# SCHOOL DEVELOPMENT STANDARD DEPARTURE ADVISORY COMMITTEE

# QUEEN ANNE ELEMENTARY SCHOOL DESIGN DEPARTURE RECOMMENDATIONS

# Project #3026198 AUGUST 21, 2017

Exhibit 4 Impact of Code Required On-Site Parking Stalls

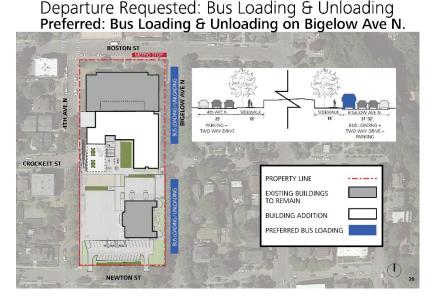
A question was asked about access to the 88 parking spaces. Ms. Rosen noted that the intent of the diagram was to show how much space of the site will be taken up so that there would be additional space from the site to provide access from the street to the parking lot but the design team is requesting to not provide the 88 parking stalls and associated access to them.

# Recommendation 2 – That the departure to reduce the parking requirement be GRANTED as requested by the Seattle Public Schools without modifications and with the following conditions:

Exhibit 6 Location of Off-site Bus Loading & Unloading on 4th Ave N.

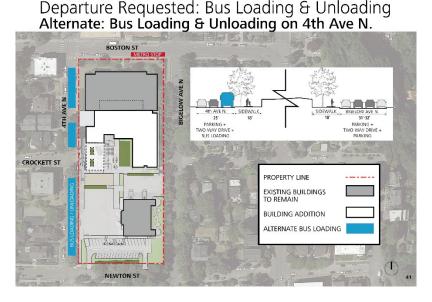
**Comment from Scott Weaver**: Mr. Weaver lives across the street at the west side of 4<sup>th</sup> Ave N. and he commented about the alternate bus proposal and requested to look at this because it will be a disaster for residents who lives there because it will take away their parking spots.
